FIRE DEPARTMENT MOBILE DATA COMPUTER RFP INQUIREIES

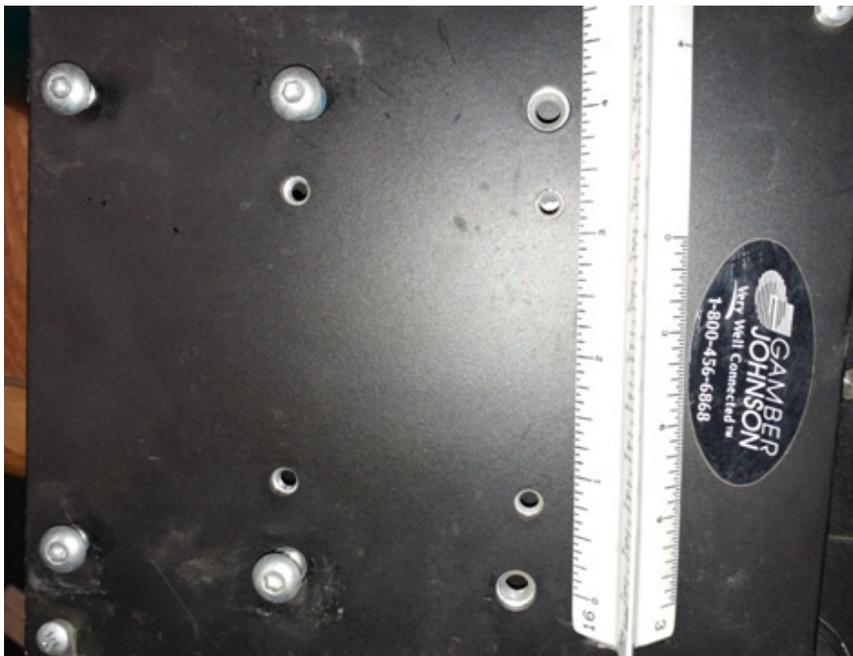
20. Are the existing MDC mounts VESA 75 compatible?

The existing mounting equipment is not compatible with the VESA 75 standard. The following pictures were taken from the vehicle mounting equipment in one of the fire engines where the existing MDC is mounted on the doghouse.

This is the bracket that attaches to the doghouse (bolts four bolts are separated two inches in a square pattern). The separation at the top of the mount has a three-inch separation (distance on the outside), and the Gamber Johnson cradle attaches to this portion of the bracket. This is the same approach as on vehicle 652 as displayed above.

This is the Gamber Johnson cradle. The two brackets are separated by three inches (on the inside of the brackets) and attaches to the bracket (see picture above) on the doghouse.

This is another view of the Gamber Johnson cradle with measurements of the holes for the bolts on the bottom of the cradle. The outer holes have a 4-inch separation, and the inner holes have a 2.5-inch separation.
